Access Compliance Report Public Rights-of-Way (Curb Ramps)

Main Street: BENJAMIN_DR		Cross Street: BENJAMIN_DR		Location:	N
ADA ID: RPRK211028162659	Ramp Type:Type 1 - Perpendicular	Initial Pass/Fail: Fail	Overall Compliance: No	Severity Score:	45

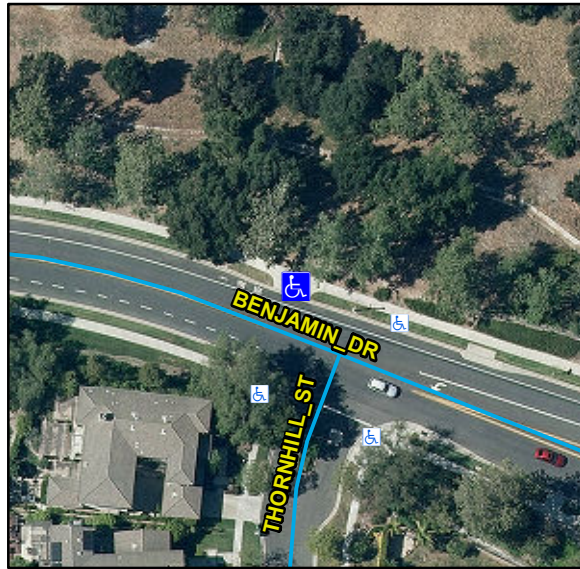
Compliance	Description	Data	Compliance	Description	Data
N/A	Ramp Length (in)	64	N/A	Flare Type LT	
Yes	Ramp Width (in)	48			N/A
No	Ramp Run Slope (%)	9.1	N/A	Flare Slope LT (%)	N/A
No	Ramp Cross Slope (%)	10.3	N/A	Flare Traversable LT	N/A
N/A	Landing Present	N/A	N/A	Flare Type RT	
N/A	Landing Length (in)	N/A			N/A
N/A	Landing Width (in)	N/A	N/A	Flare Slope RT (%)	N/A
N/A	Landing Run Slope (%)	N/A	N/A	Flare Traversable RT	N/A
N/A	Landing Cross Slope (%)	N/A	N/A	DWS Provided	N/A
N/A	Landing Movement Obstructed?	N/A	N/A	DWS Contrast	N/A
	Landing Movement Type	N/A	N/A	DWS Length (in)	N/A
N/A	Landing Shared	N/A	N/A	DWS Full Width	N/A
N/A	Clear Space	N/A	N/A	DWS Offset Left (in)	N/A
N/A	Clear Space To Crosswalk (in)	N/A	N/A	DWS Offset Right (in)	N/A
N/A	Marked Crosswalk 1	No	N/A	Marked Crosswalk 2	N/A
	Crossing 1 Direction	SW		Crossing 2 Direction	N/A
	Marked Crosswalk 1 Width (in)	N/A		Marked Crosswalk 2 Width (in)	N/A

N/A	Ramp Inside Crosswalk 1	N/A	Yes	Ramp Inside Crosswalk 2	N/A
	Crossing 1 Slope (%)	9.9		Crossing 2 Slope (%)	N/A
	Crossing 1 Cross Slope (%)	5.6		Crossing 2 Cross Slope (%)	N/A
N/A	Gutter Ponding	N/A	No	Curb Slope	13.3
Yes	Gutter Lip Height (in)	0		Road Run Slope (%)	N/A
N/A	Gutter Run Slope (%)	N/A		Road Cross Slope (%)	N/A
N/A	Gutter Cross Slope (%)	N/A			
Yes	Overall Surface Condition: Acceptable		No	Perp Joint Present	No
	Cross Gutter Present?	No		Spandrel Present?	No
	Replace Cross Gutter?	N/A		Replace Spandrel?	N/A

Remove & Replace Entire Ramp.
